AURORA BUILDING INSPECTION
ELECTRICAL SECTION
APPROVED
SUBJECT TO COMMENTS AS NOTED
AND FIELD INSPECTIONS

CITY OF AURORA
BUILDING DIVISION
APPROVED AS NOTED
DATE APPROVED DEC 23 2009
Reference only.

Medical Office Building

1455 S. Potomac
M.C.O.A. South Campus
Cath Lab #4
Aurora, Colorado 80012

01 FIRST FLOOR PLAN - LIGHTING
SCALE: 1/4" = 1'-0"

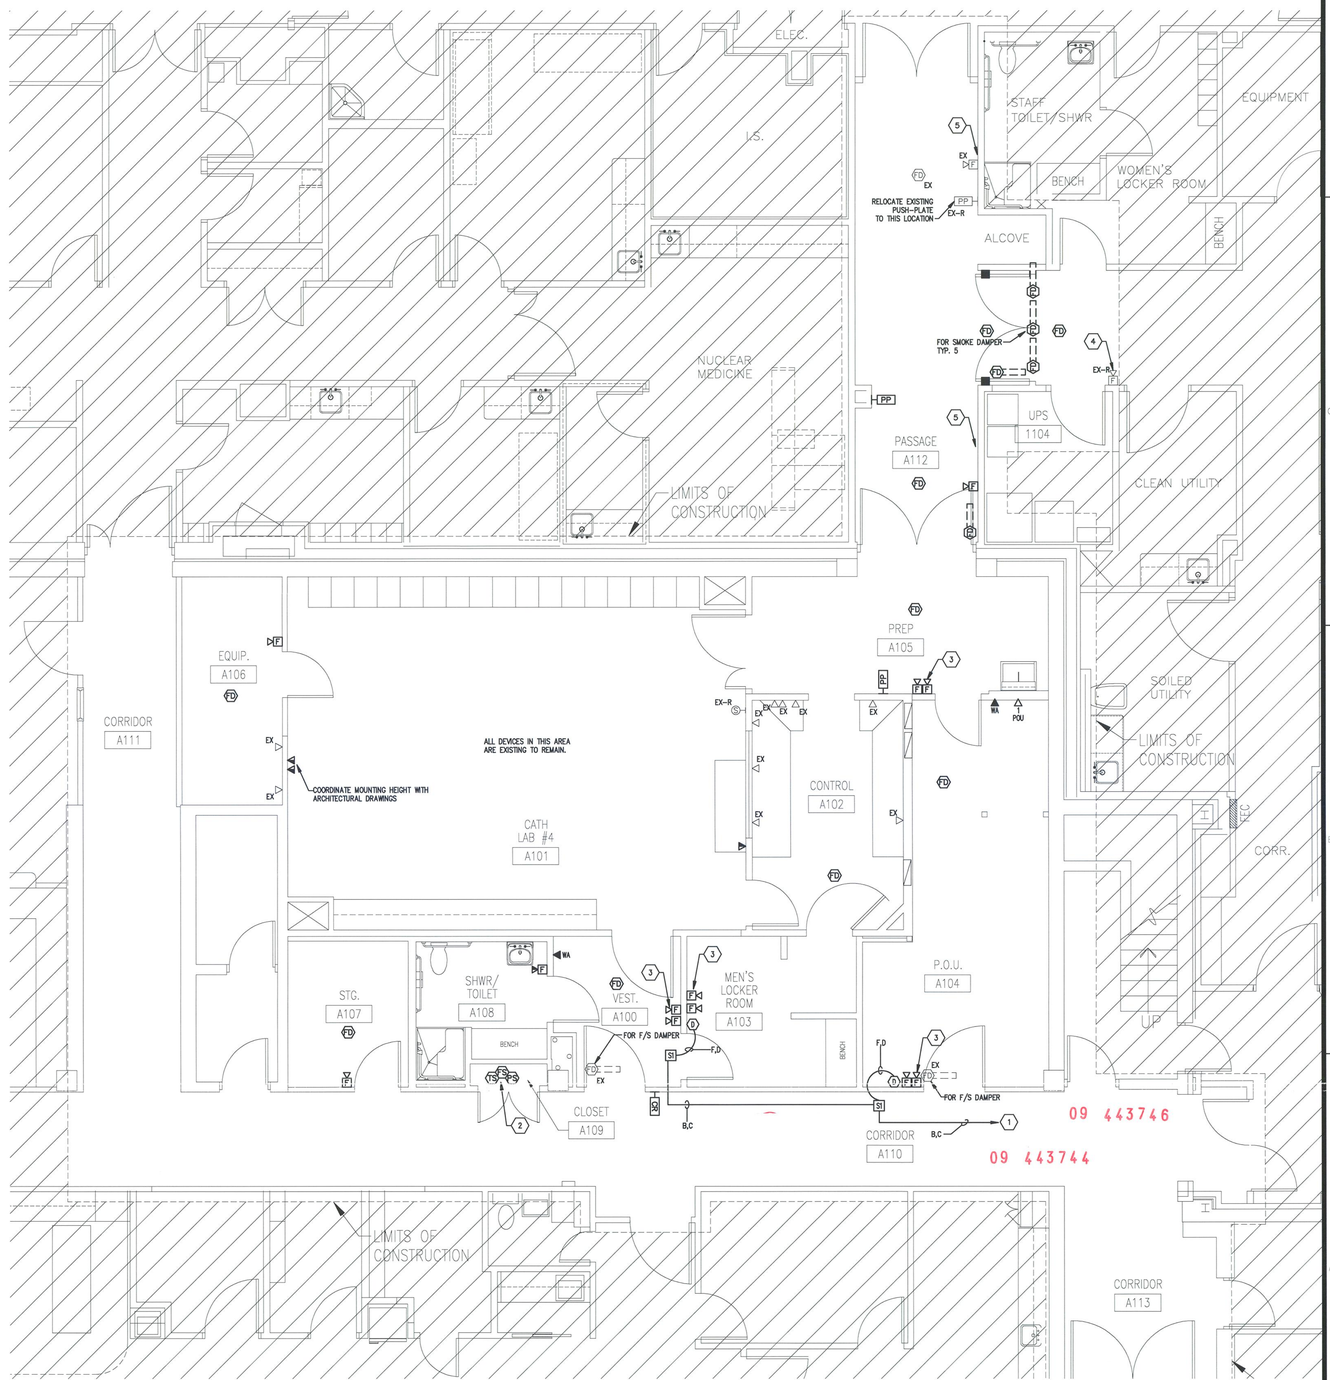
Wiring in air handling spaces must comply with 2008 NEC 300-22. Firestop penetrations per 2008 NEC 300-21. Secure and support equipment per 2008 NEC 300-11.

Provide emergency illumination equipment that complies with 2008 NEC 700-12 (F) or 2008 NEC 700

After hours inspection to verify required egress illumination may be required during field inspection. 2006 IBC 1006.

see the comcheck Lighting Compliance Certificate for lighting control requirements for minimum code requirements to the 2006 IECC, section 505. Typical.

PARTIAL MOB EXISTING ONE-LINE DIAGRAM

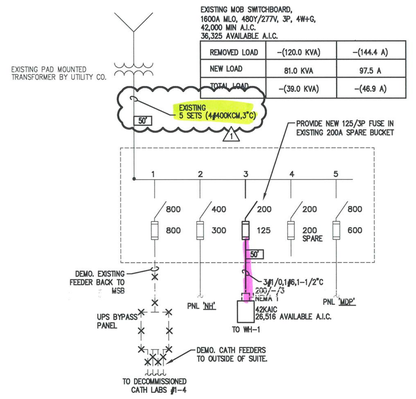
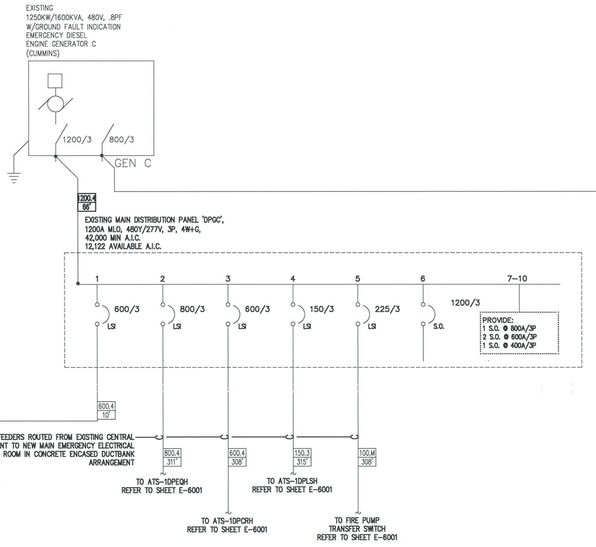
Provide a grounded electrode system bonded to the service equipment enclosure, grounded conductors, and grounded electrode conductors per 2008 NEC 250-50 and 250-104.

Locate the required overcurrent protection per 2005 NEC 240-21.

Install electrical connections per 2008 NEC 110-14, identify disconnects per 2008 NEC 110-22 and provide working space around electrical equipment per 2008 NEC 110-26.

ELECTRICAL ONE–LINE DIAGRAM

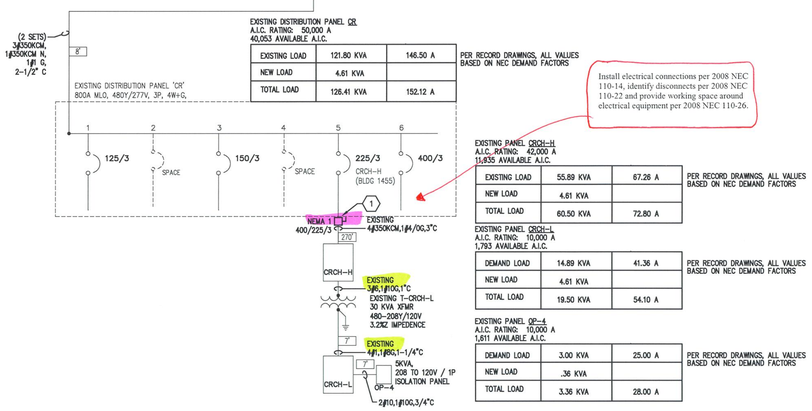
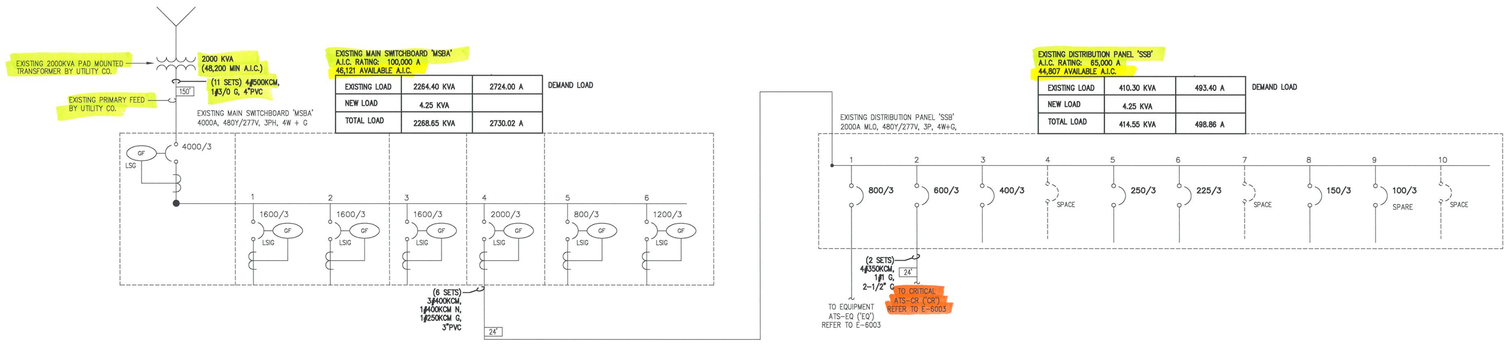
Install electrical connections per 2008 NEC 110-14, identify disconnects per 2008 NEC 110-22 and provide working space around electrical equipment per 2008 NEC 110-26.
